## Search Result for HOWARD COUNTY

RE: Proposed resubdivision of Lot 4  
Charles L. & Marlene Wright property

RE: C. Wright Property, Lots 1 to 4

Charles Wright Prop  
9/17/82 Permit Plat

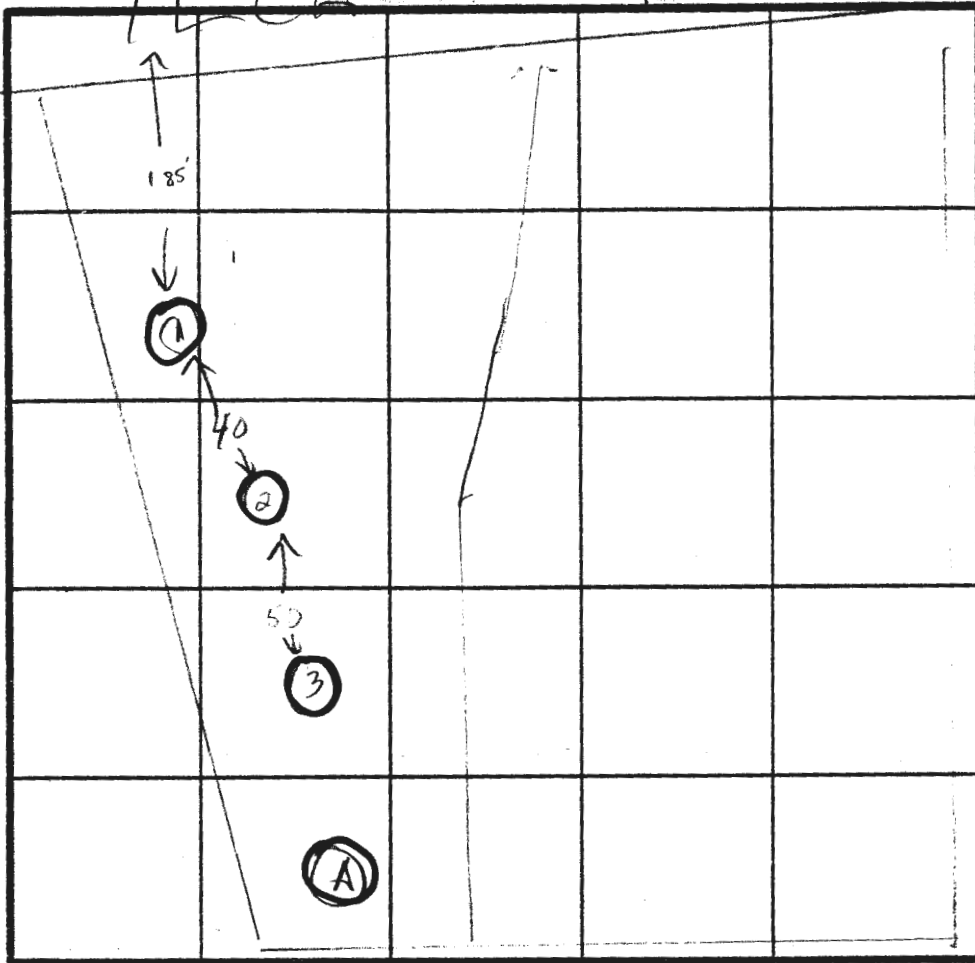
REASONS FOR REJECTION OR HOLDING 11' CLAY ACROSS LOT. C. Williams

DATE	TEST NO.	DEPTH	PRE-WET		TEST - 1" DROP		TIME
			START	STOP	START	STOP	
2-6-84	(1)	11	YELLOW CLAY	(BAND OF SAND 1" THICK AT 6')			X FAILS
2-6-84	(2)	9	DISTURBED SOIL (CLAY)				X
			BURIED DEBRIS AT 8'				
2-6-84	(3)	11	YELLOW CLAY				X
1975	(A)		HOLE DUG ON PREVIOUS TEST				1975 FAILED

REMARKS FAILS - NO PERC
